THE FOLGER SHAKESPEARE LIBRARY

## U.S. Commission of Fine Arts Permit Review – Follow-up

16 April 2020

**PROPOSED FOUNTAIN DESIGN VIEW FROM GARDEN**  
THE FOLGER SHAKESPEARE LIBRARY - U.S. COMMISSION OF FINE ARTS

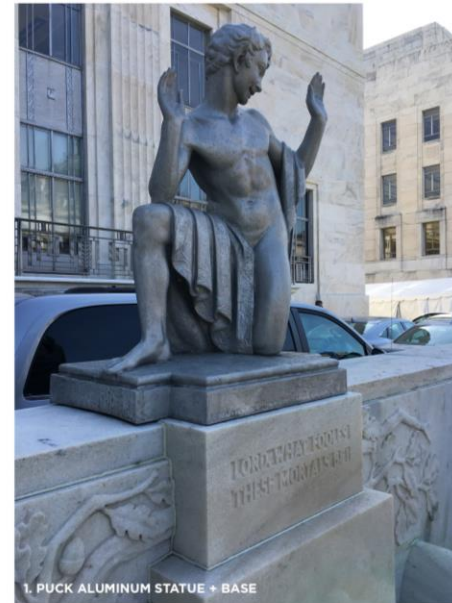
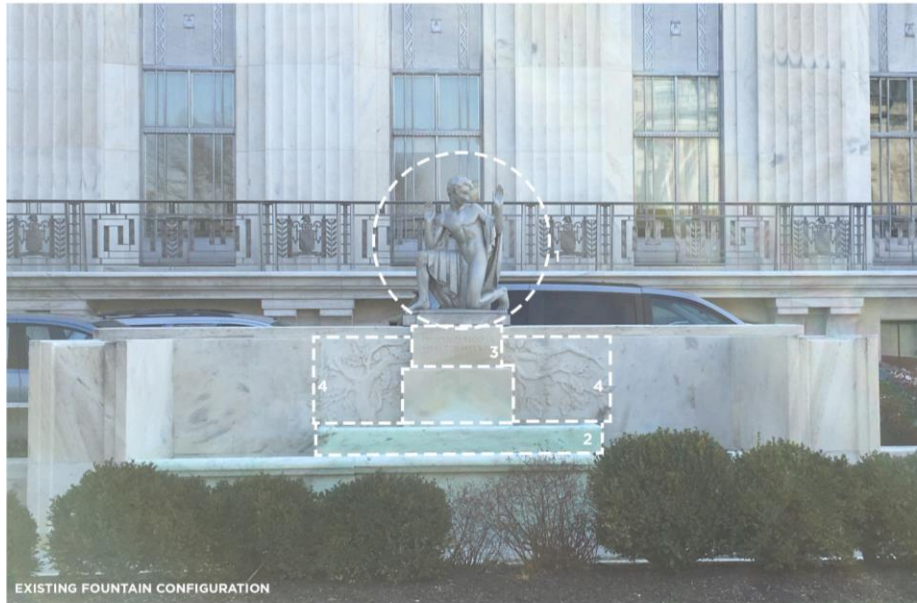
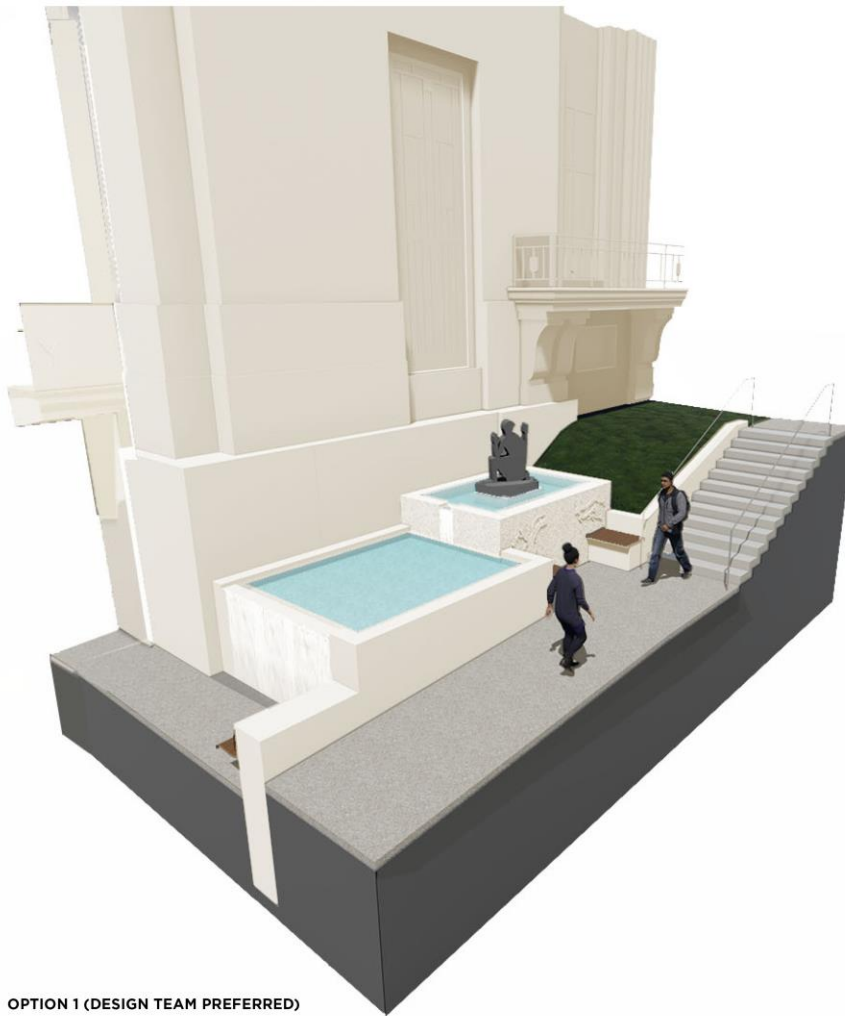
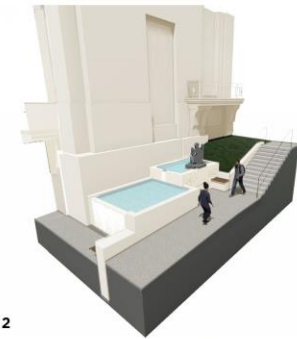
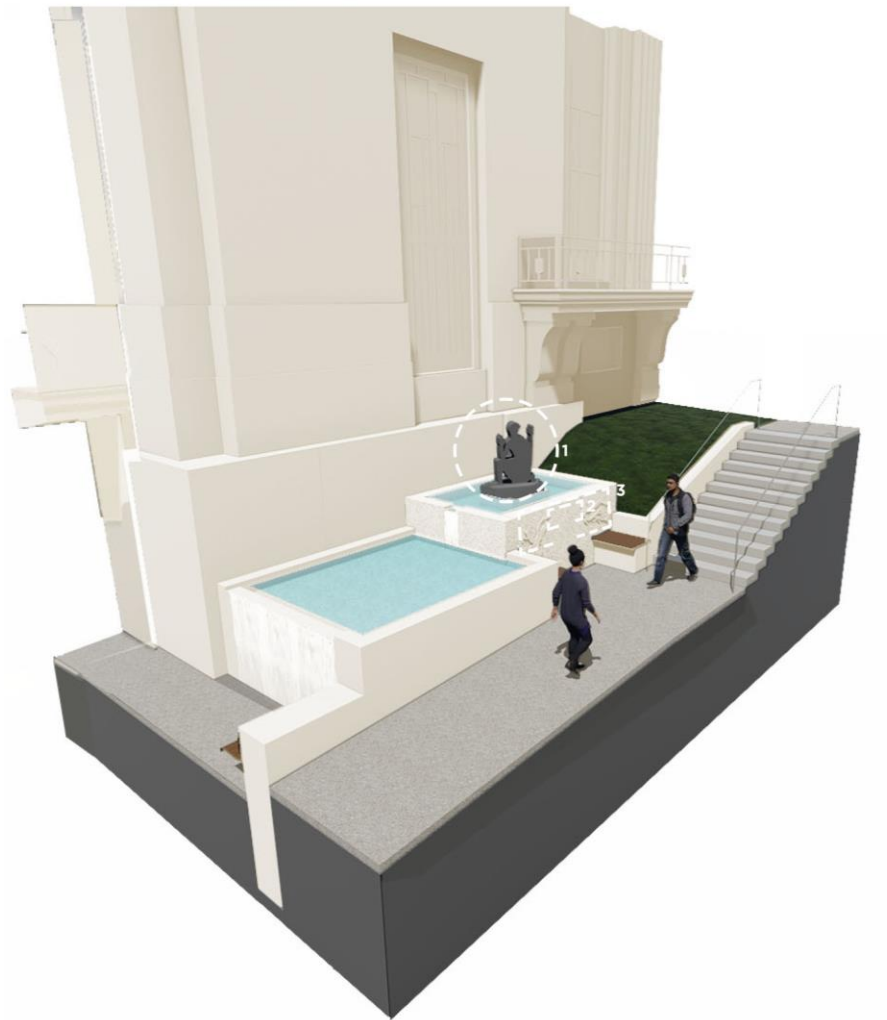
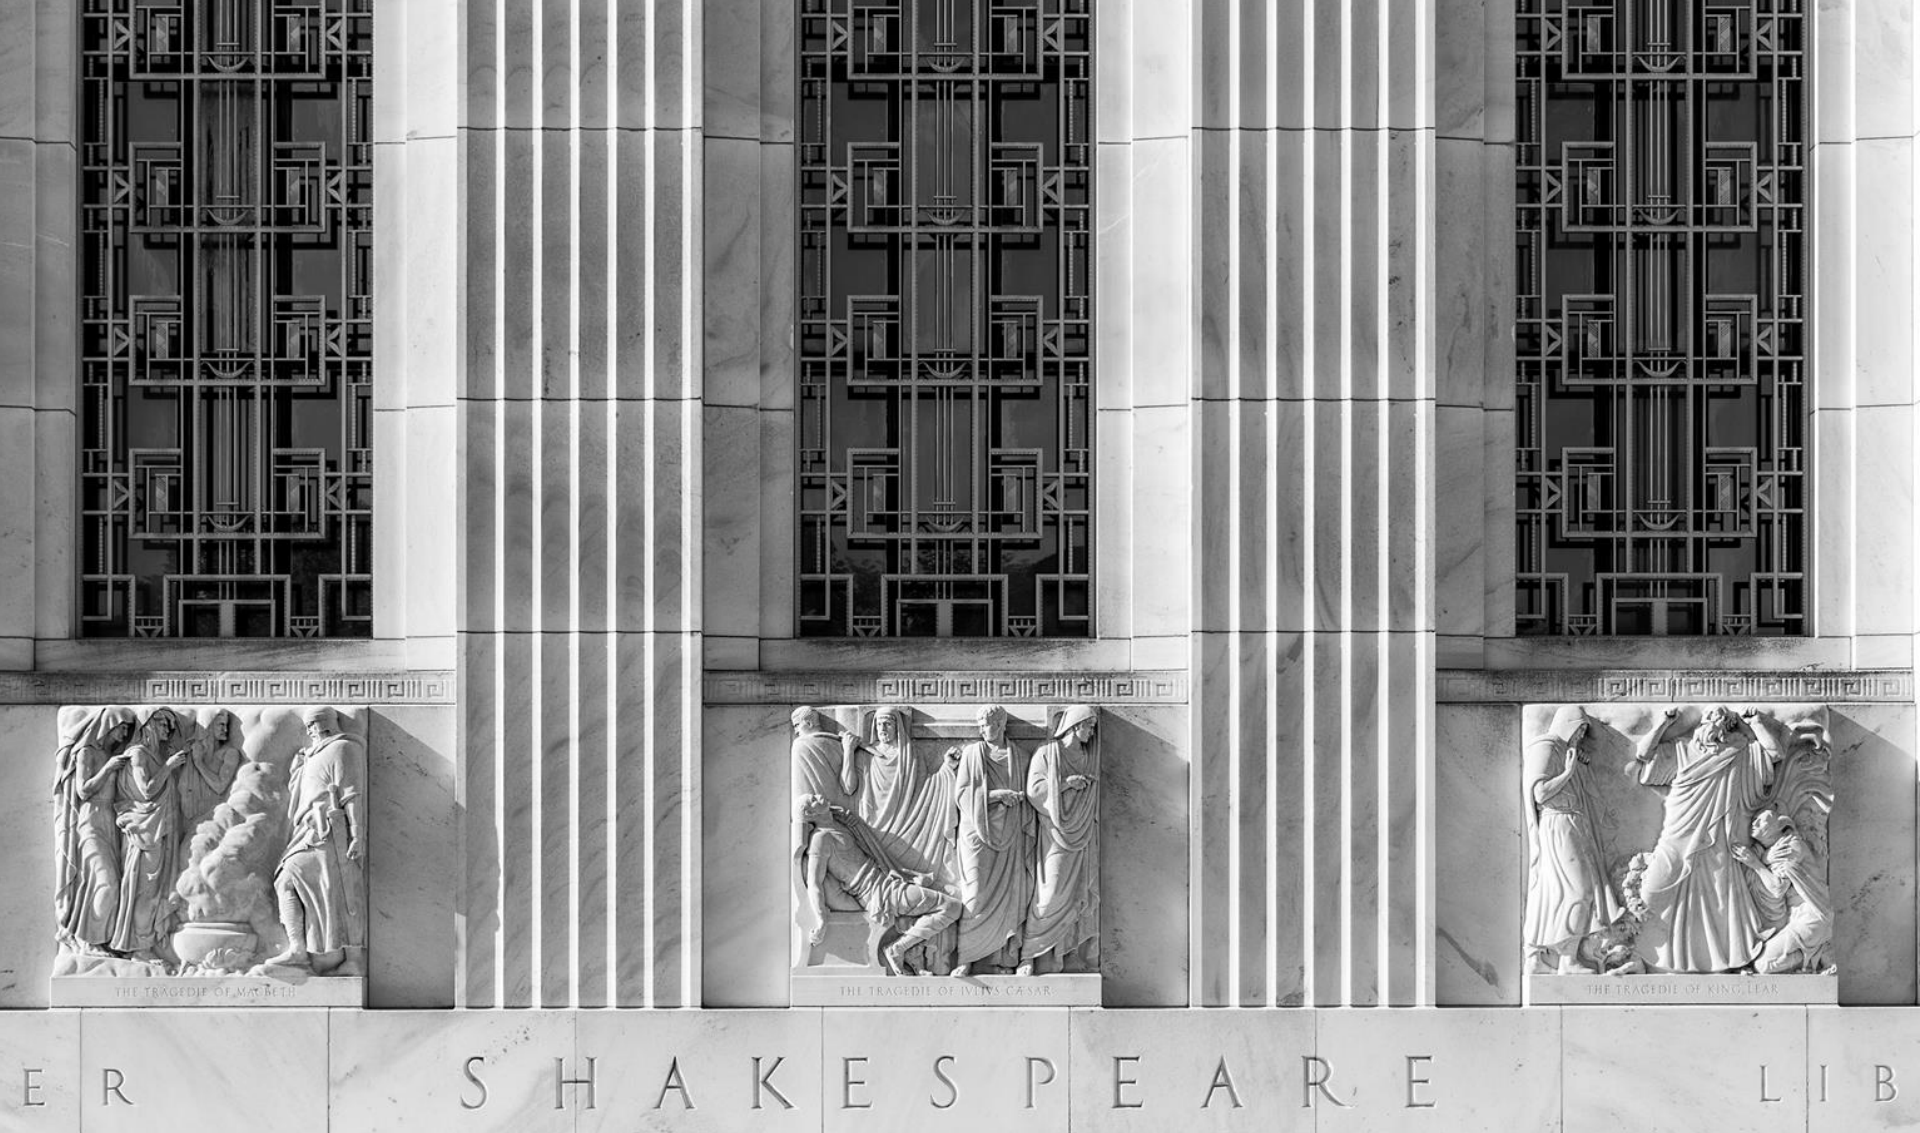
“Finally, the Commission members requested that the original pedestal for the Puck sculpture be incorporated in its new location.”

OPTION 1 (DESIGN TEAM PREFERRED)
